## 1 Products affected

New colour of inlet gasket. Old gasket with black colour new gasket in blue.

5707					0118.2298	
creation date	created by	release date	released by	notification no.	revision	page
2015-07-23	hollenpe	2015-08-17	hollenpe			1 of 2

Old product appearance	New product appearance

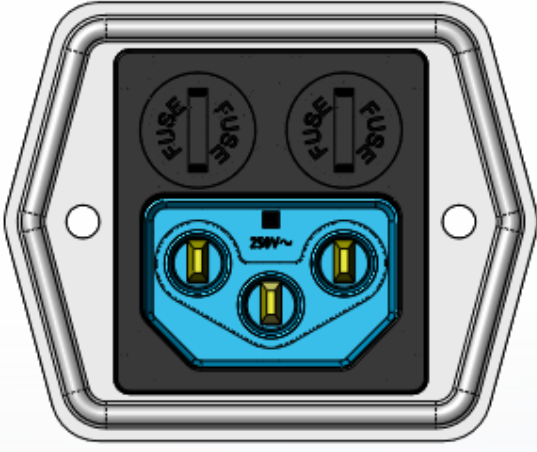
Better visualization of the IP54 protection of cord connection for 5707 with inlet gasket. Safer and easier identification for the end user.
